# **Historic Landmark Commission Meeting Agenda**

RE: 1212 Fiorella Street - Alteration Review

RE: 1715 Amelia Street - Alteration Review

**ELEVATIONS**

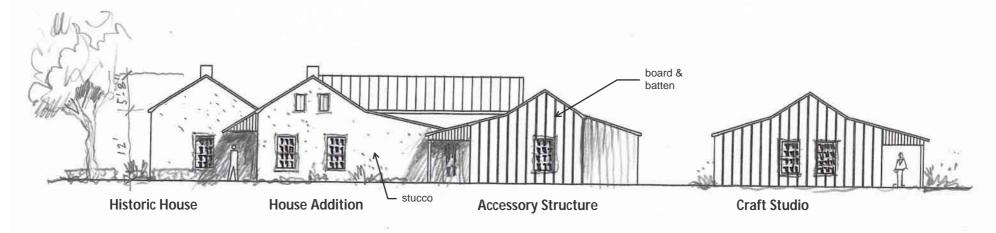
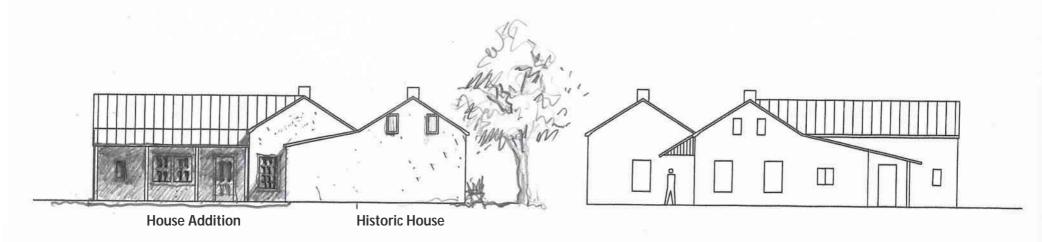
- 7. Per the Castroville Design Guidelines, Section II, Additions (pg. 11), design an addition to be lower than the original building so the historic one predominates. In the elevations, the height of the additions appears to be the same height as the 1970 portion of the home. <u>It is recommended that the roof peak of the proposed additions be lower than the peak of the original 1870 home.</u>

- 7. Per the Castroville Design Guidelines, Section II, Fences and Walls (pg. 36), the height of your fence should complement the house, not overwhelm it. This usually means a fence will measure about two-and-a-half (2.5) to four (4) feet from the ground to the top of the fence. Consider a fence height of three (3) feet or less for the front yard. The four-foot (4) fences common today were not typical historically. Please verify the height of the low dry stack stone wall/fence.
